NL201175

Re: Tomago Resource Recovery Facility and Truck Parking Depot – 21D and 21F School Drive Tomago
Soil and Water Management Plan – Addendum**Background**

This addendum letter is intended to address each of the comments raised by each individual agency in relation to the Soil and Water Management Plan. The information presented within this document is to supersede that of the relevant sections in the of the Soil and Water Management Plan (Revision E).

Figure 1 – Wash Bay located in Proposed Heavy Vehicle Workshop (21D School Drive)

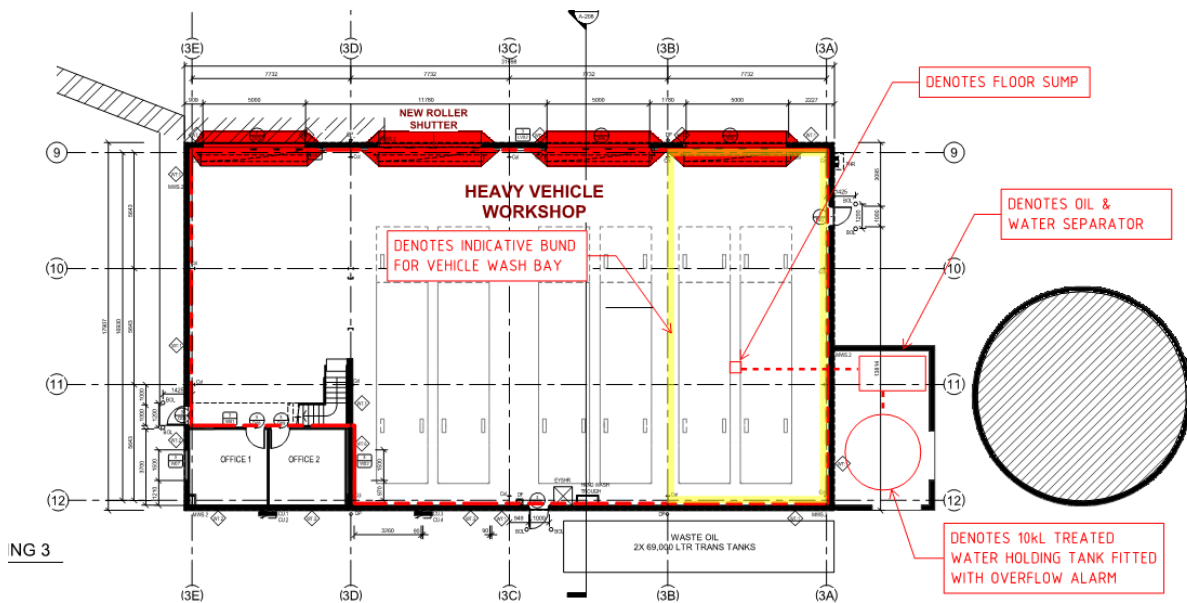
“Council’s comments on the SEARs requested a Waste Management Report be provided to demonstrate that the existing on-site sewer management and trade waste systems are appropriate for the proposed development. This report has not been provided. The site is mapped as being very high hazard, indicating the site contains or is located in proximity to sensitive environmental constraints. The EIS notes that the existing system would be sufficient for the new development however, little justification has been given to support this claim.”

To confirm the adequacy of the existing system, or otherwise, it is recommended that a Waste Management Report, prepared by a suitably qualified person, be provided by the applicant.”

In addition, a vehicle washdown bay is proposed to be installed within the heavy vehicle workshop. The vehicle wash bay will be bunded internally within the building with proposed screens to be installed to ensure full water capture. Run-off from the truck wash will be collected by existing floor sumps that will drain the water to a pit in the shed on the northern side of the maintenance workshop. Water will be treated in an oil/water separator and pumped to a 10kL holding tank also located in the shed. The tank will be periodically pumped out, with treated water sent for off-site recycling in accordance with Remondis' existing tankering agreement with Hunter Water. Figure 1 illustrates the indicative bunding and wash bay within the workshop.

The wastewater, which may contain small amounts pollutants from the waste material handled by the trucks will be stored and transported off-site as trade waste to be treated and disposed at a licenced facility.

Figure 2 – Indicative Pavement Detail – Extracted from NL201175 C5.1 Rev B

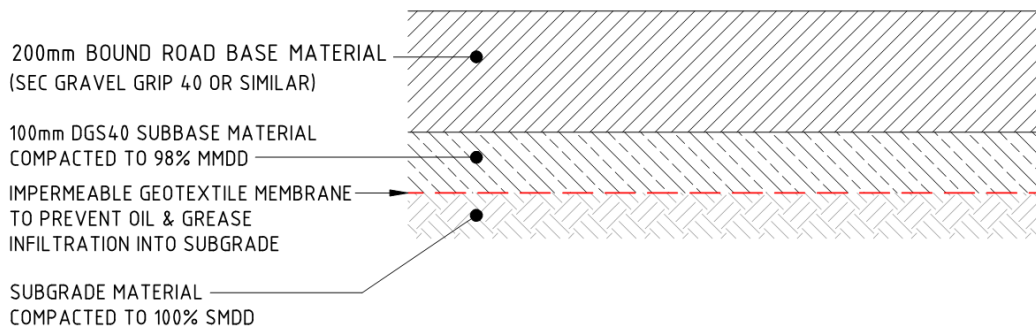
“Demonstration that the proposed cap over 21F School Drive would be appropriately designed and constructed to prevent percolation of rainwater through the underlying contaminated soils. The Applicant should provide details of the proposed cap, including its:

- *composition;*
- *thickness (mm); and*
- *in situ saturated hydraulic conductivity (m/sec).”*

Despite the subsequent findings in the groundwater assessment, a capping has been proposed for the extent of the new parking depot to achieve two primary objectives. The first is to maintain consistency with the outcomes of the Remediation Action Plan, and the second, is to prevent ingress of additional pollutants that may occur from the truck parking depot (for example small oil leaks or spills).

Figure 2 presents the proposed pavement design extracted from the revised engineering plans prepared by Northrop for the parking area, composed of 200mm bound road base material with an impermeable geotextile layer.

The pavement will fall towards stormwater pits where water will be captured, treated, and directed to the infiltration system. The hydraulic conductivity of the road pavement layer is not critical due to the presence for the impermeable geotextile layer. Any surface runoff not captured by the pavement layer will flow as surface runoff and be collected via the stormwater pits installed within the pavement extents. The runoff generated from surface overland flow and the stormwater collected by the subsoil drainage system are directed to the same discharge location after processing through the treatment train.

DRAWING TITLE
INTERNAL CIVIL WORKS CONCEPT STORMWATER MANAGEMENT & LEVELS PLAN
SHEET 3

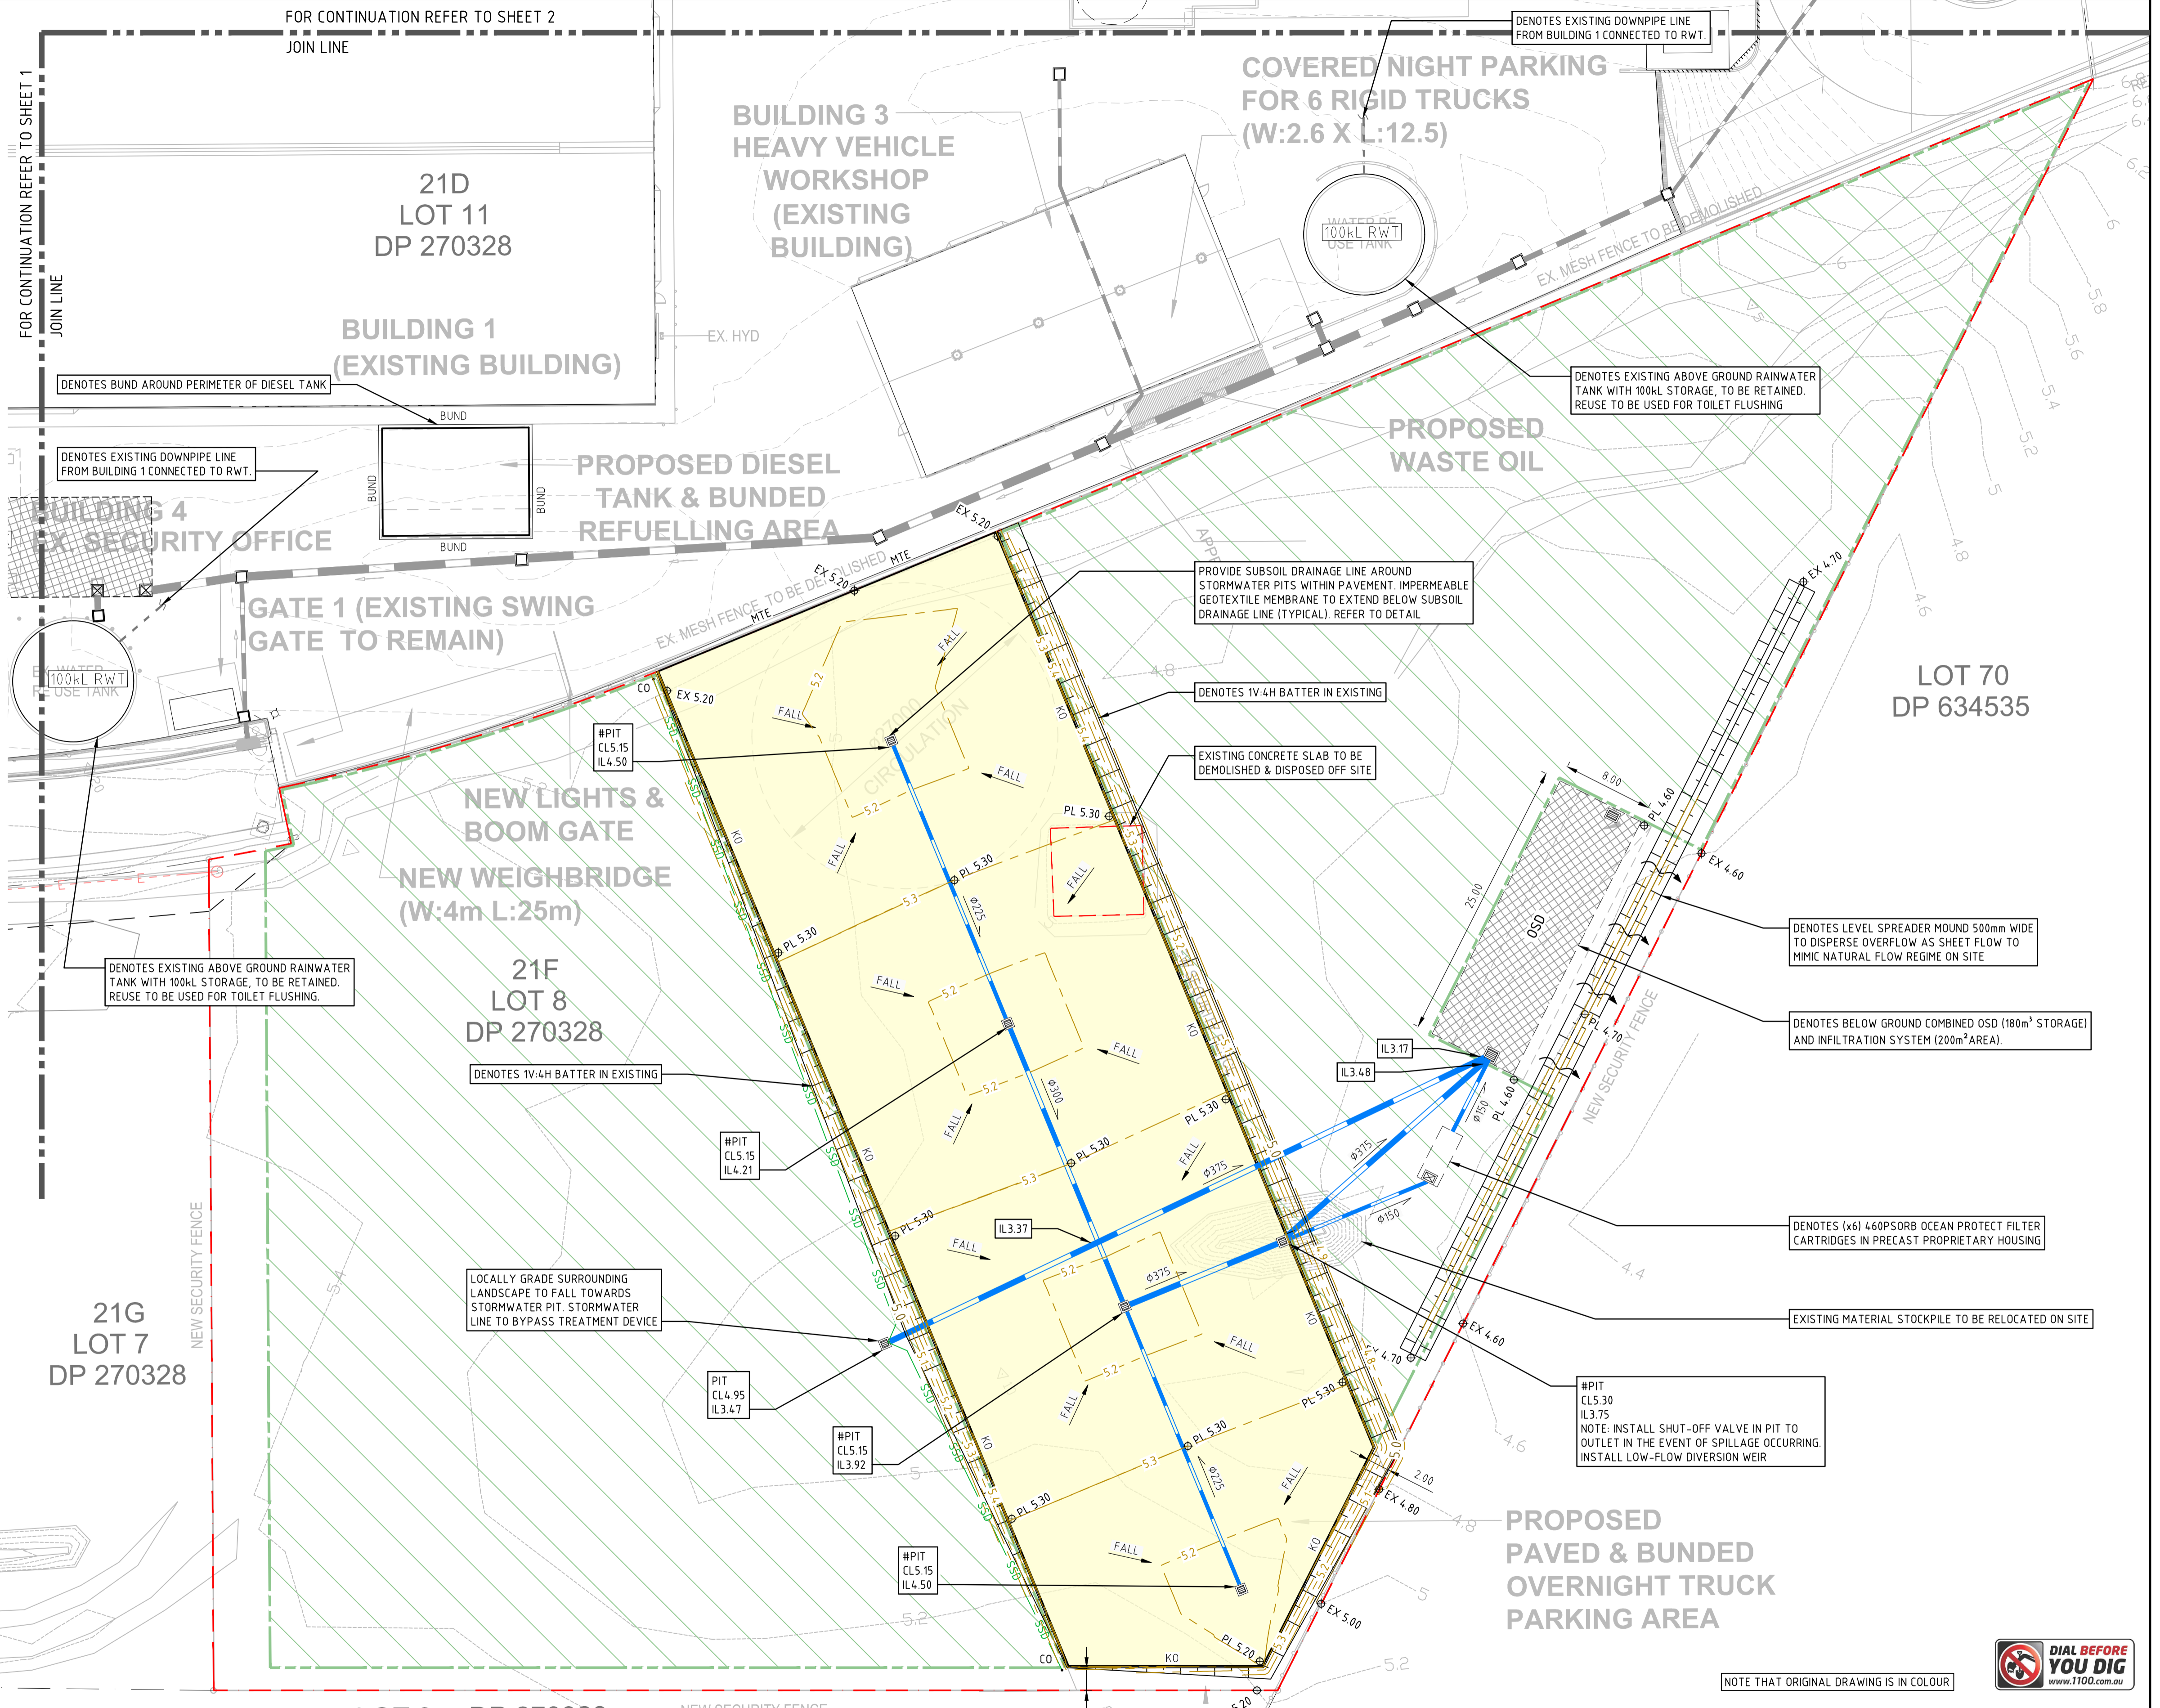
“The proposed stormwater design does not appear to be supported by any water quantity modelling. A Drains model should be provided to demonstrate the Infiltration system is designed to cater for all 1% AEP post development flows. The natural catchment has high infiltration and it is believed that the subject site won’t produce any significant runoff even for the major storm events.

Accordingly the Drains model should use the assumption that the pre-development flows, for up to and including 1% AEP event are zero.”

The below ground infiltration system has been modified from the initial design to increase the size to achieve the required detention outcomes. The proposed detention sizing is proposed to be 180m³ as presented in the revised engineering plans (refer attached).
